RE: School Development Application DA2022/0390, The Southern Parkway Forster - Traffic Peer Review

SCT Consulting was requested to undertake a peer review of work completed by Seca Solution in support of the Development Application to support a response to a request for information by the Midcoast Council.

Figure 2 Original (now superseded) design

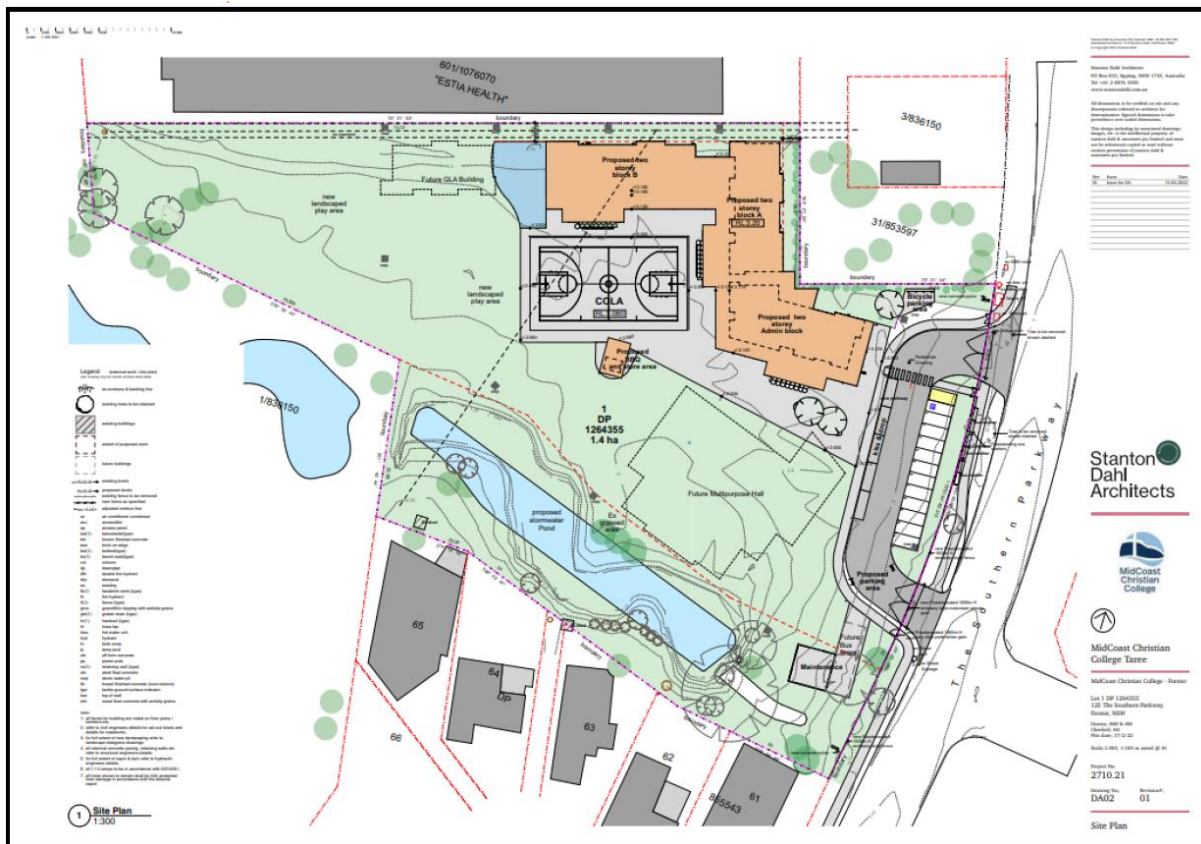
Based on this design, the Council noted:

Referring to Section 3.2.4 of the TIA, we refer to the following commentary provided in relation to queuing for the proposed development:

- “no queuing is expected for the traffic entering and exiting the site”.

Reviewing this statement in conjunction with commentary provided for the access points and circulation, we would also refer to the commentary provided in Section 3.4.4:

- “Allowing for a maximum of 120 cars approaching the site”; and
- “In the morning drop off, the vehicles can arrive on site over a 20-30 minute period and as such the majority of this drop off can occur within the site and create minimal on-street parking demands accordingly”.

Based on these statements, it is expected a maximum of 120 cars will require use of the drop off zone during the morning period. On-site parking with 5 spaces would need to meet an expected turnaround time frame of 1 minute 15 seconds from entering the site to exiting. This excludes any delays associated with entry and exit movements.

Referring to the previous commentary, we can advise that the concerns raised as part of the circulation are further exacerbated by these calculations to which we cannot provide support for the proposed layout in its current form.

It is inferred that Council is concerned that a pick-up or drop-off time of 1 minute and 15 seconds would be unlikely to be achieved. In response, the design has now been superseded by that proposed in **Figure 1**. This design has a parallel parking aisle of approximately 48m in length on the eastern side. Based on AS2890.1 Figure 2.5, this space would cater for eight parallel parking spaces (**Table 2**).
